SUNDRY NOTICES AND REPORTS ON WELLS
Do not use this form for proposals to drill or to re-enter an abandoned well. Use form 3160-3 (APD) for such proposals.

8. Well Name and No.
WILLIAMS B FEDERAL 11

THIS IS A REQUEST TO RECOMPLETE THIS YESO WELL TO THE SAN ANDRES.

Conditions of Approval

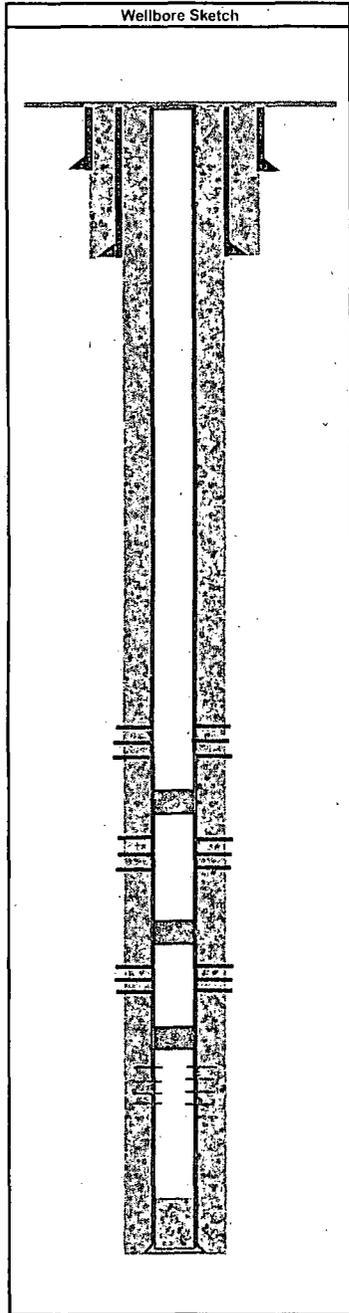
10. Operators procedure approved as written with the following additions:

11. After setting the isolation plug above the Yeso and before perforating, perform a (charted) casing integrity test of 700psig. Verify all annular casing vent valves are open to the surface during this pressure test. Pressure leakoff may require correction for approval. Include a copy of the chart in the subsequent sundry for this workover.

12. Provide BLM with an electronic copy (Adobe Acrobat Document) of any existing cement bond log record. The CBL may be attached to a pswartz@blm.gov email.
